ADDENDUM NO. 1
TO THE PLANS, SPECIFICATIONS, PROPOSAL AND CONTRACT
FOR CITY OF LACEY
CARPENTER ROAD/BRITTON PARKWAY ROUNDABOUT
LACEY CONTRACT NO. PW 2020-29

Issued this 8th day of December 2023.

DRAWING NUMBER
IR3 A
SHT 63 OF 64

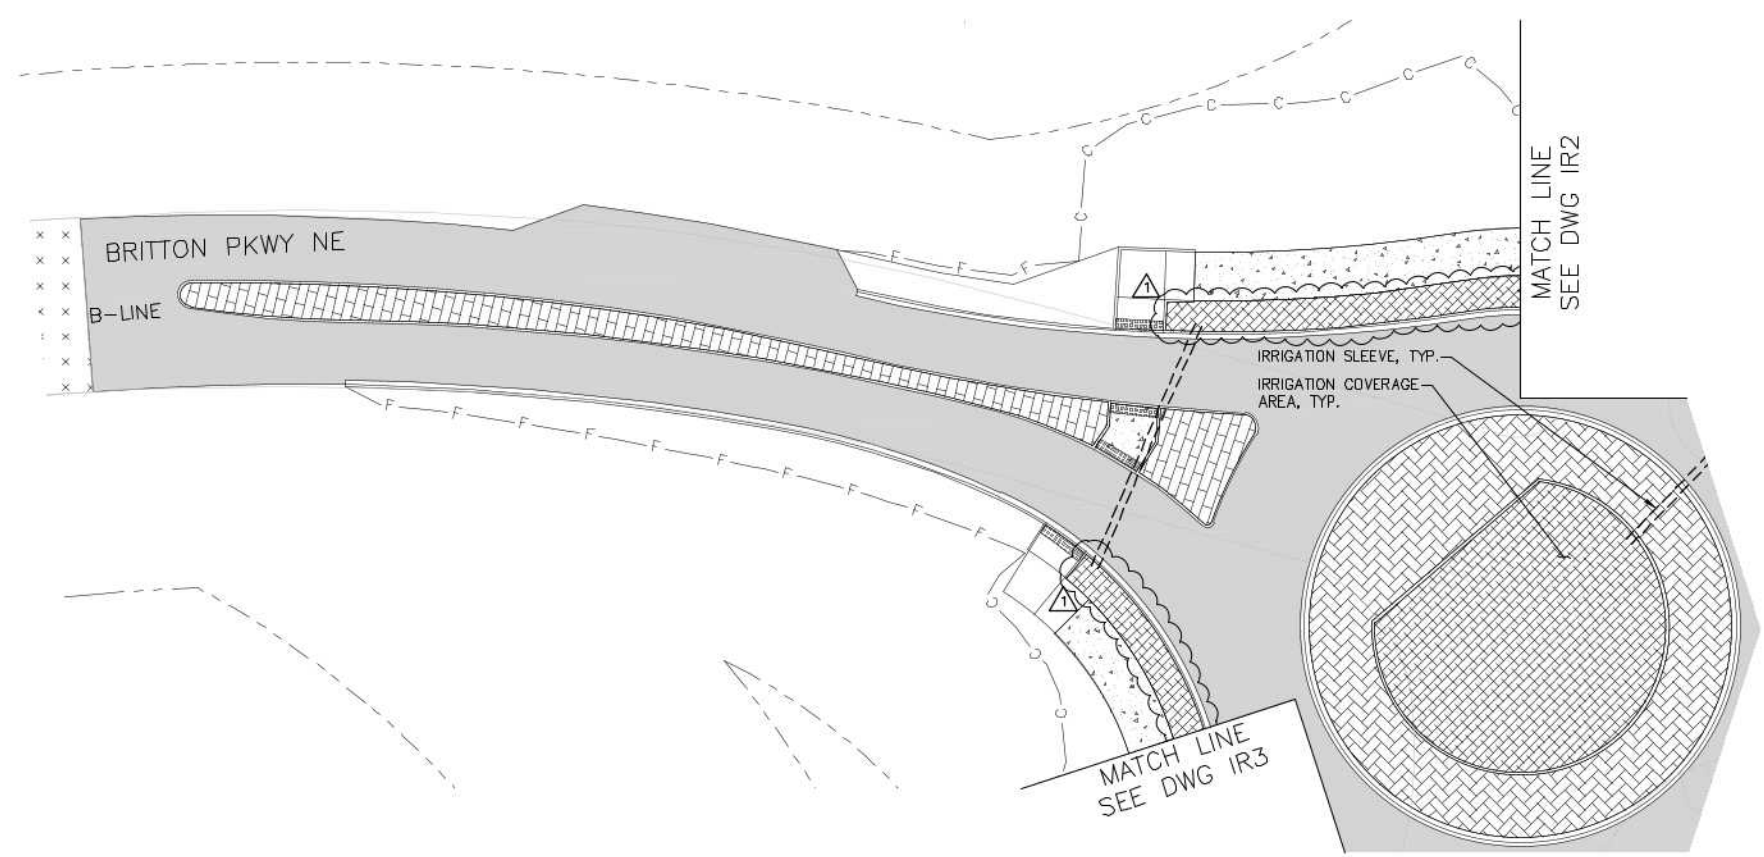
Replace sheets IR1-IR3 (61-63) with the attached revised IR1A-IR3A, the planter strip area was inadvertently left off the plans. The revised sheet shows the complete irrigation coverage area.

NO.	DATE	BY	APPR.	REVISIONS
1	11/30/23	RDL		EXTEND IRRIGATION COVERAGE AREA TO PLANTING STRIPS

DRAWING NUMBER
IR1A
SHT 61 OF 64

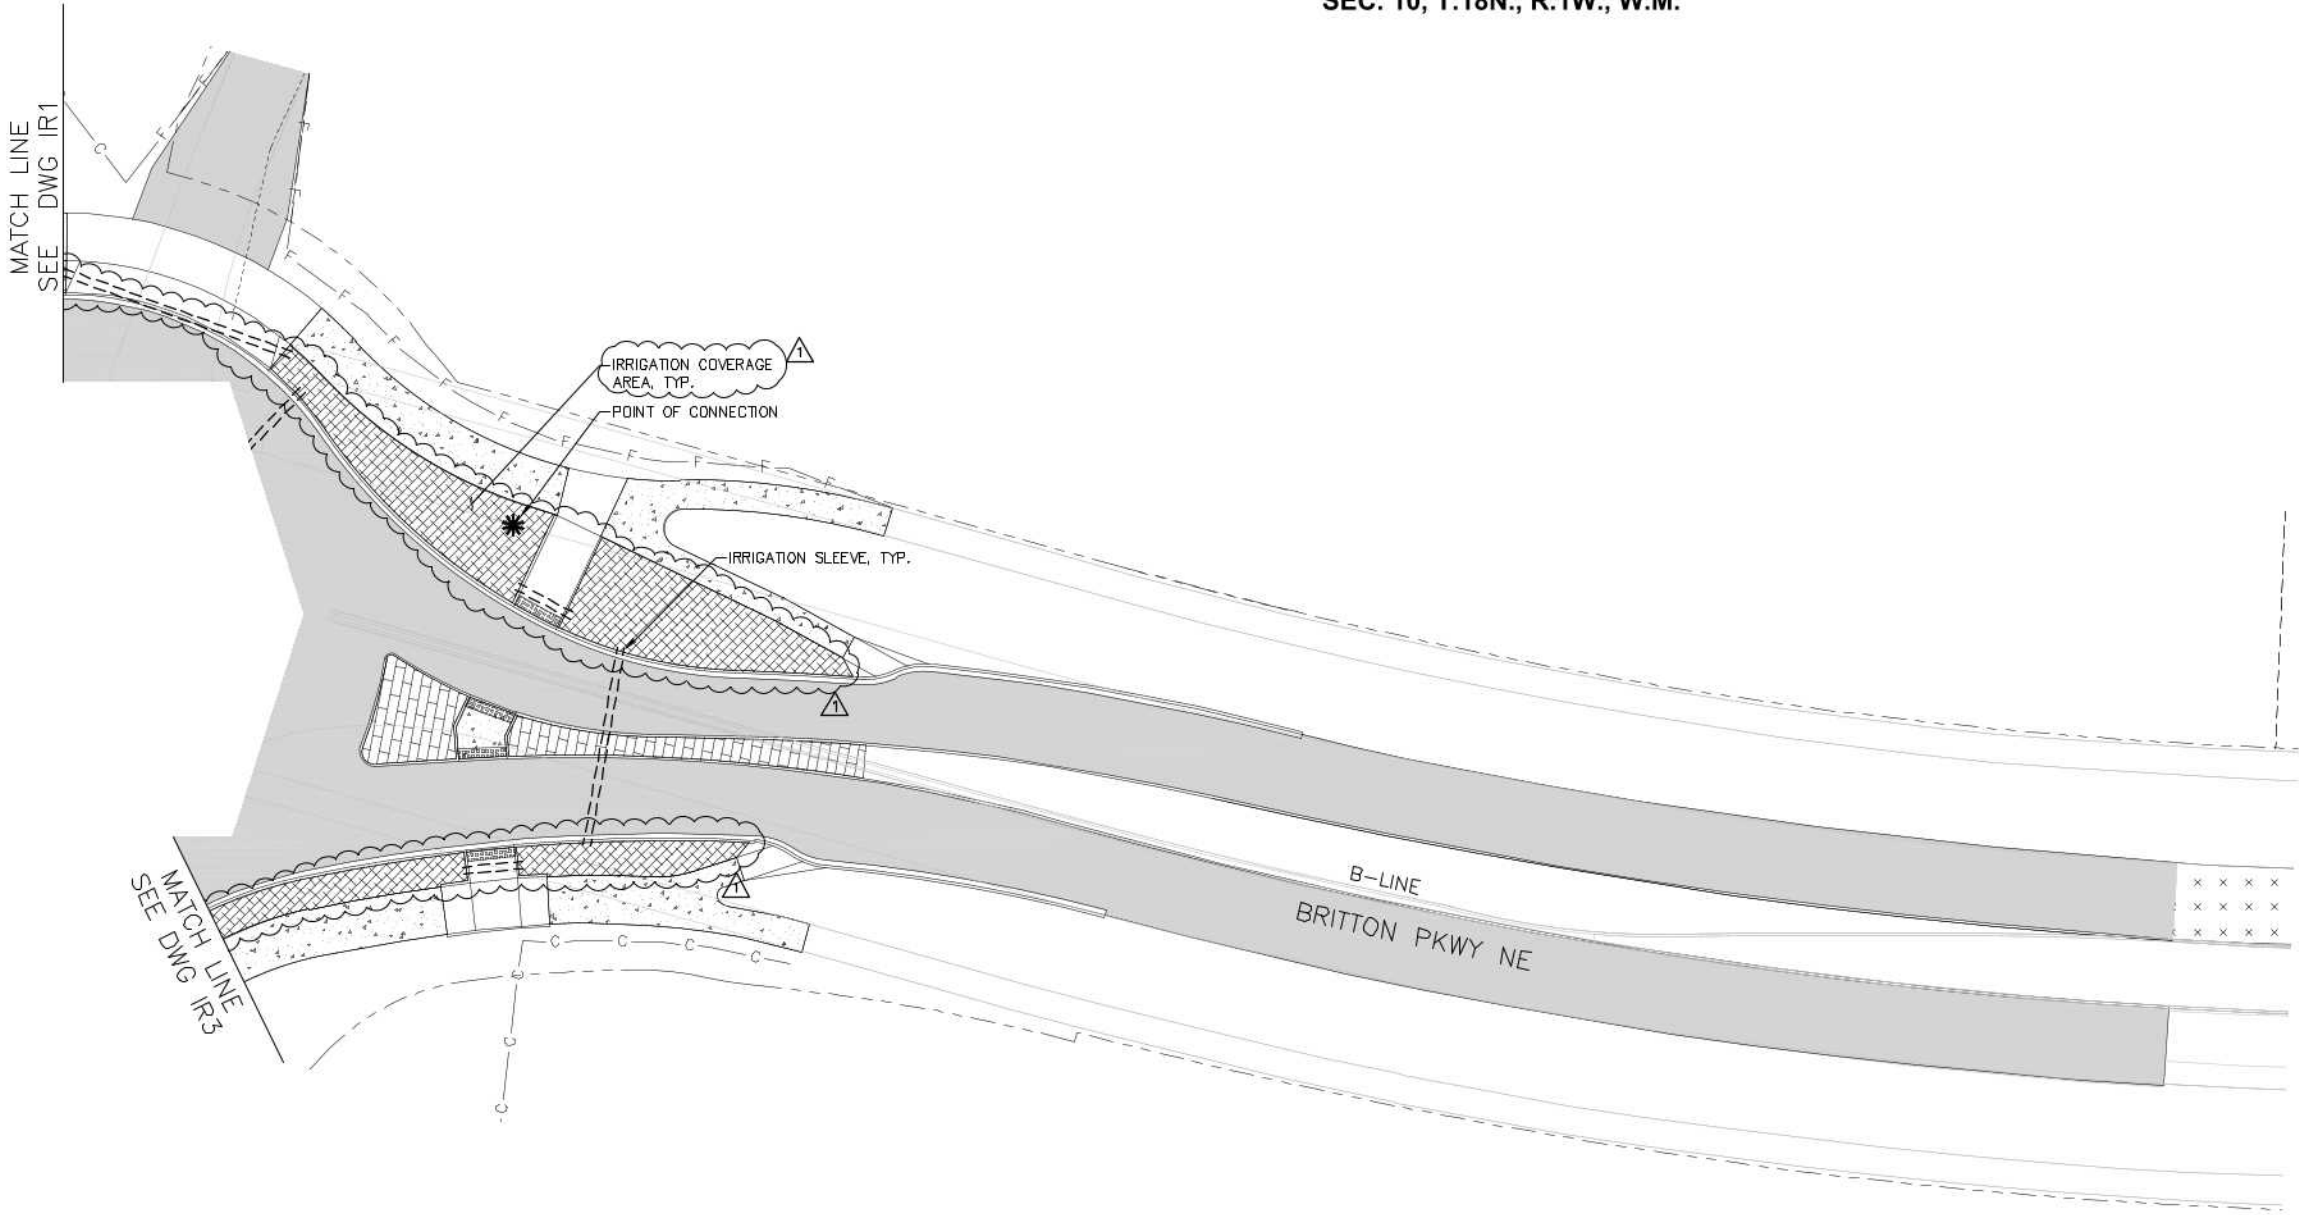
NO.	DATE	BY	APPR.	REVISIONS
1	11/30/23	RDL		EXTEND IRRIGATION COVERAGE AREA TO PLANTING STRIPS

DRAWING NUMBER
IR2A
SHT 62 OF 64

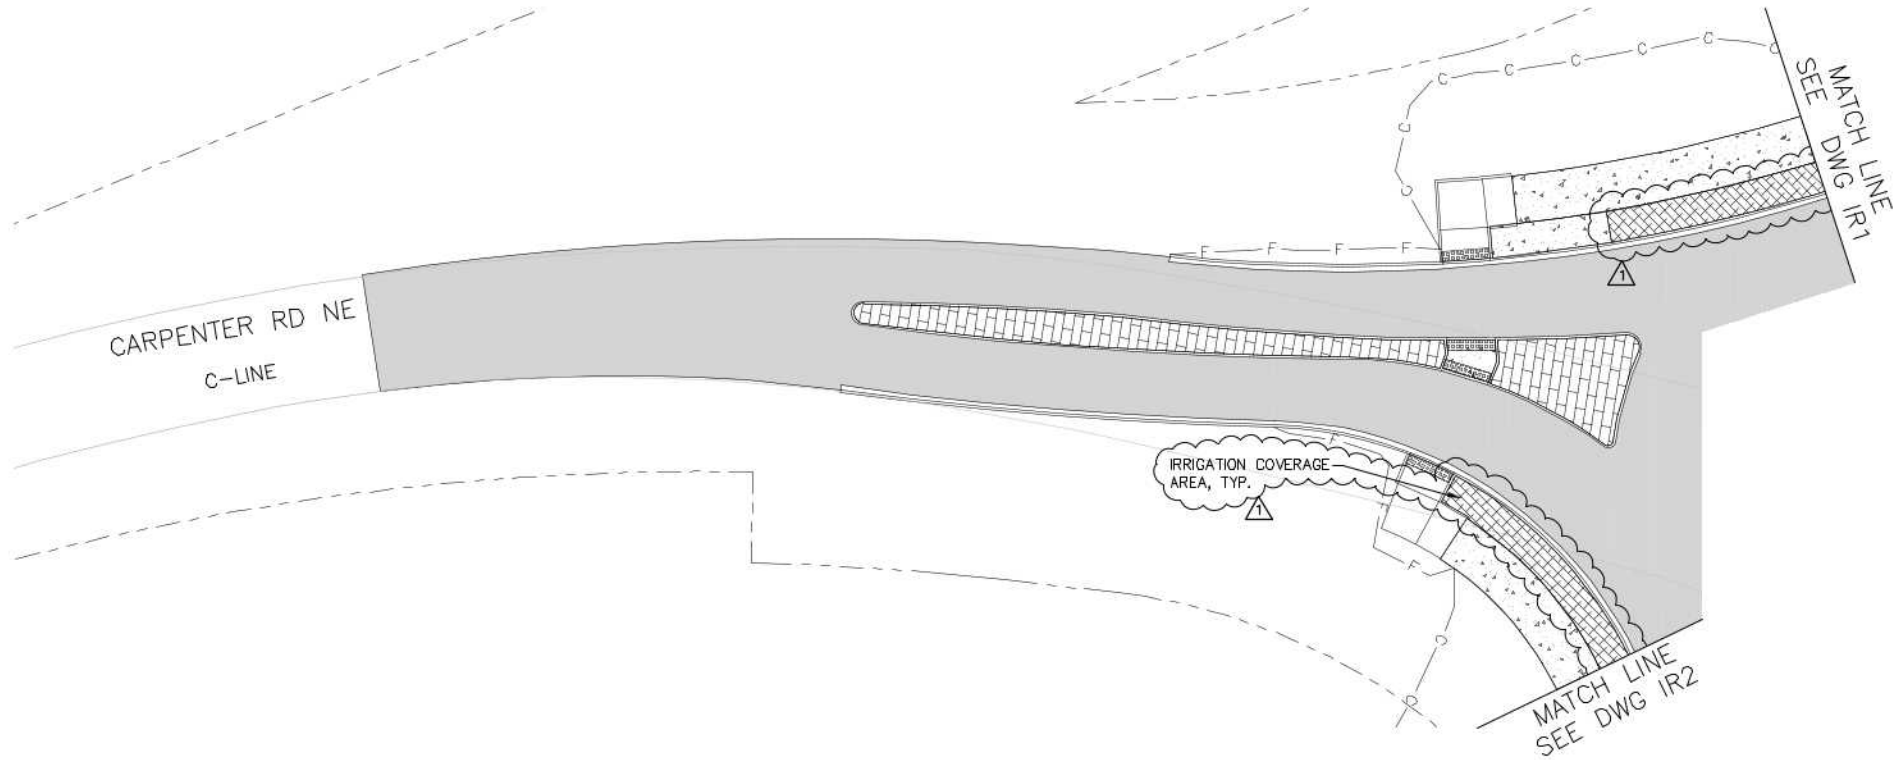
NO.	DATE	BY	APPR.	REVISIONS
	11/30/23	RDL		EXTEND IRRIGATION COVERAGE AREA TO PLANTING STRIPS

RP1

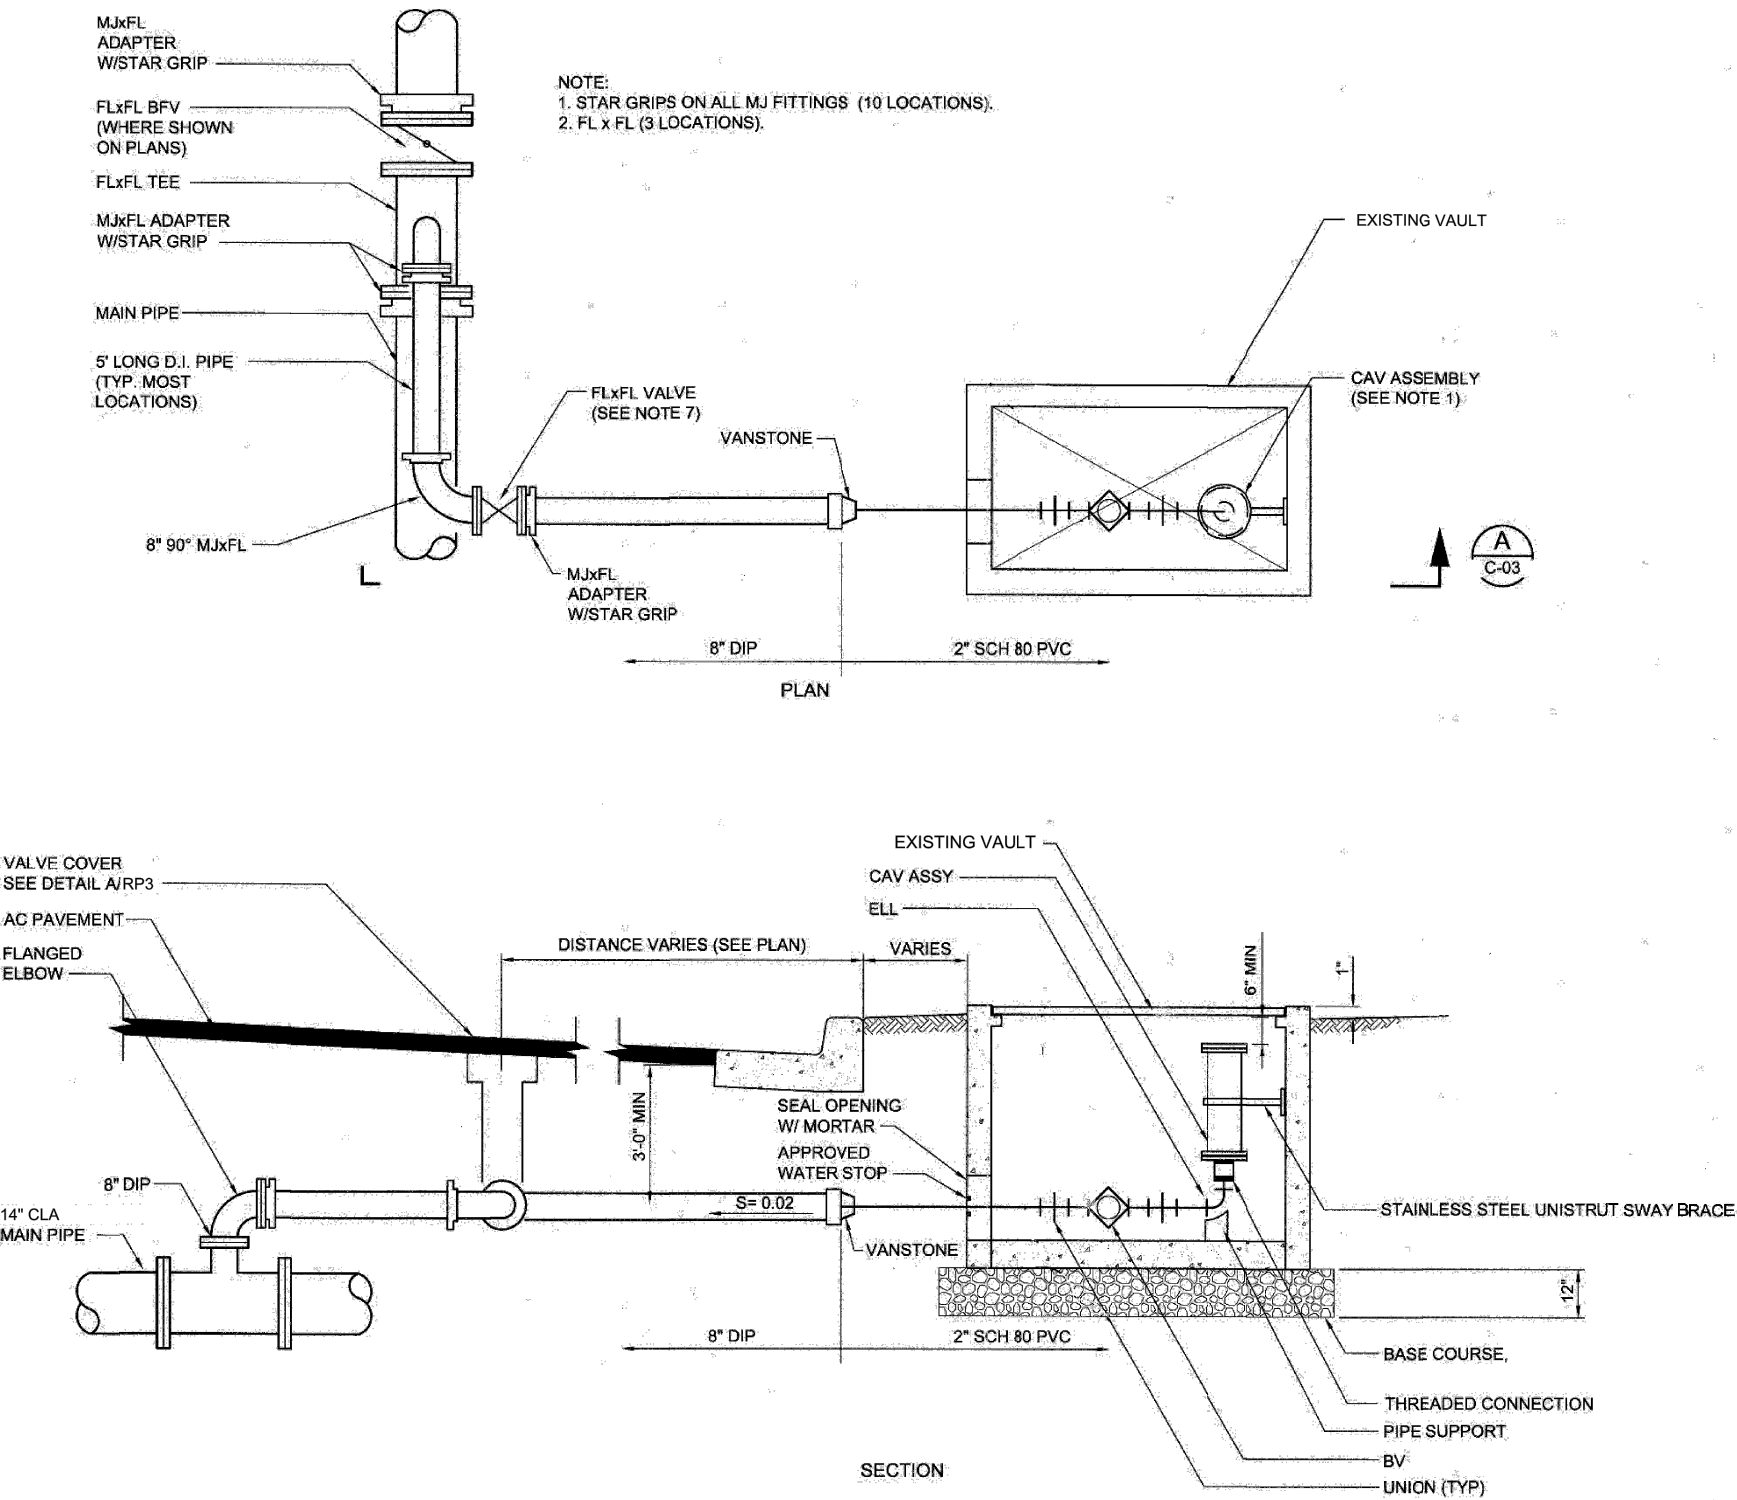
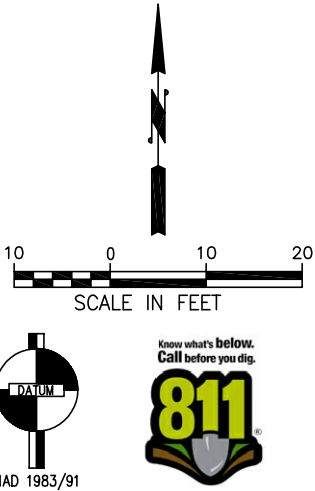
Include the attached plans and specifications to relocate the LOTT Clean Water Alliance facilities that conflict with the project. A new schedule has been added to the proposal to reflect this work. Replace proposal pages B-4 and B-5 with pages B-4A, B5A, and B-6A which includes the Reclaimed Water Schedule.

1. CONTRACTOR SHALL CUT OUT A SECTION OF 14" DI SOUTH OF THE NEW CURB LOCATION. CUT OUT AND MOVE THE EXISTING SECTION OF 14" MAINLINE WITH THE 2 EXISTING VALVES AND REINSTALL IT WITH 14" DI MJ SLEEVES AND MEGALUG (OR EQUAL) RESTRAINT GLANDS. RE-INSTALL EXISTING VALVE RISER PER CITY STANDARD. FOR REFERENCE SEE DETAIL A SHEET RP2 AND DETAIL B SHEET RP3. CONTRACTOR SHALL PROVIDE AND INSTALL 14" DI PIPE SEGMENT FOR CONNECTION. DETERMINE LENGTH IN FIELD (APPROXIMATELY 5').
 2. RELOCATED AIR VALVE VAULT AND PIPING. FOR REFERENCE SEE DETAIL A SHEET RP2
 3. ADJUST VALVE RISER AND HANDHOLD TO GRADE. SEE SHEET UD3 FOR DETAIL. REPLACE LIDS WITH SLIP-RESISTANT SURFACE LABELED AS RECLAIMED WATER.
1. PROVIDE AND INSTALL RECLAIMED WATER MARKING TAPE AND PURPLE TONING WIRE FOR NEW PIPE SEGMENTS. SPLICE NEW TONING WIRE TO EXISTING TONING WIRE PER SPECIFICATIONS.
